**INLAND FOUNDATION ENGINEERING, INC.**  
**Consulting Geotechnical Engineers and Geologists**  
**www.inlandfoundation.com**  
**P.O. Box 937, San Jacinto, California 92581**

June 25, 2018  
Project No. C522-001

Re: Addendum to Geotechnical and Geologic Review Report dated June 14, 2018  
Response to Review Comments  
Existing Commercial Building Site and Proposed Charter School  
1091 Esplanade Avenue  
San Jacinto, California

# State of California Earthquake Fault Zone Map (Alquist-Priolo)

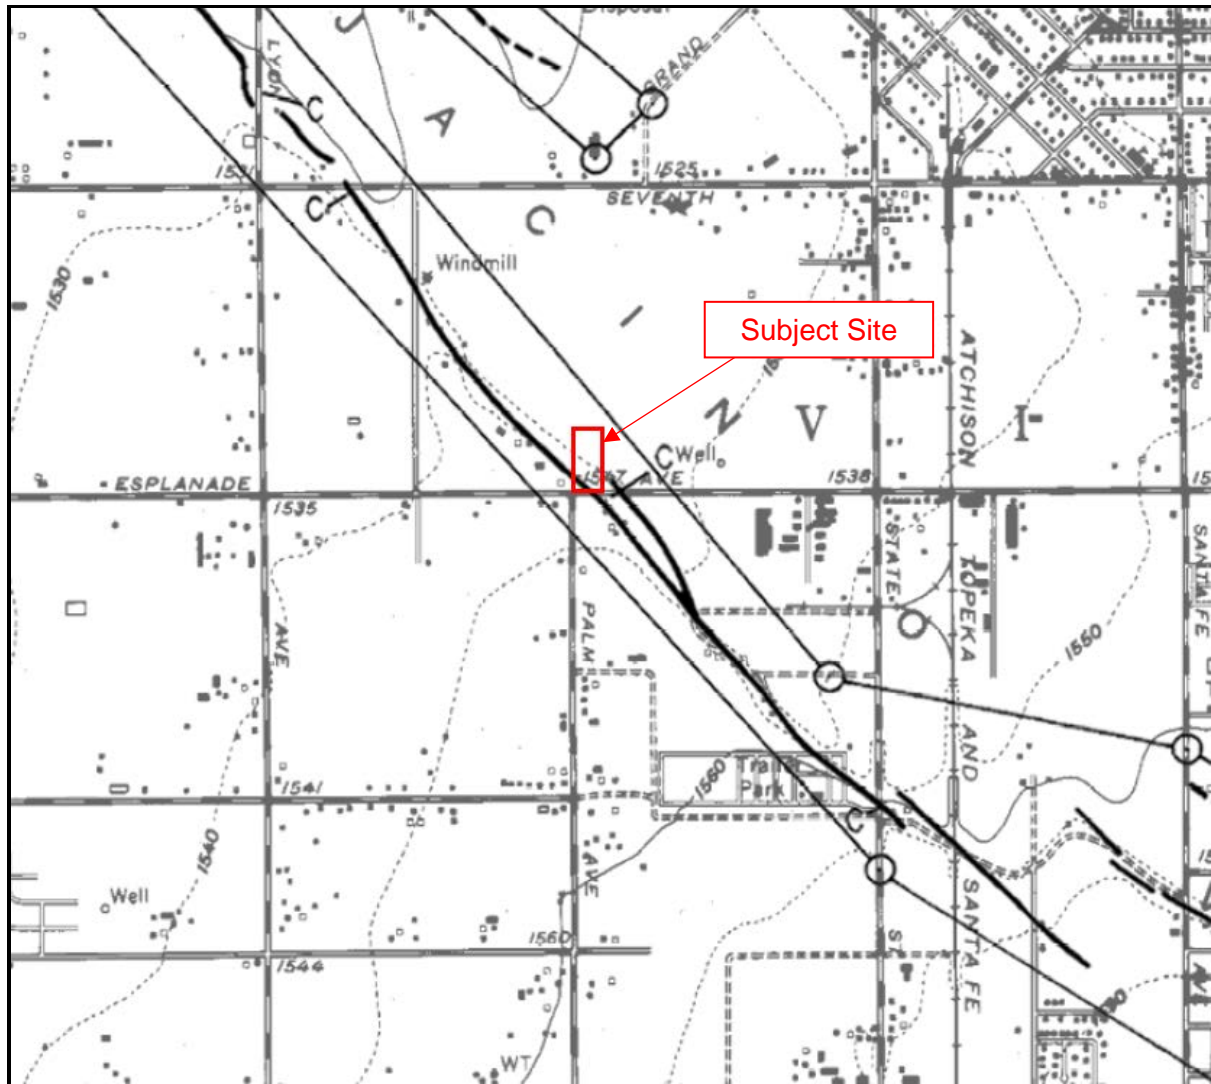
**2. Include a map of the Alquist-Priolo Zone in relation to the site.**

Attached is a portion of the State of California Earthquake Fault Zone Map (Alquist-Priolo), San Jacinto 7.5' Quadrangle (C.D.M.G., 1980) depicting the mapped special studies earthquake fault zone associated with the Casa Loma Fault and the approximate location of the subject site.
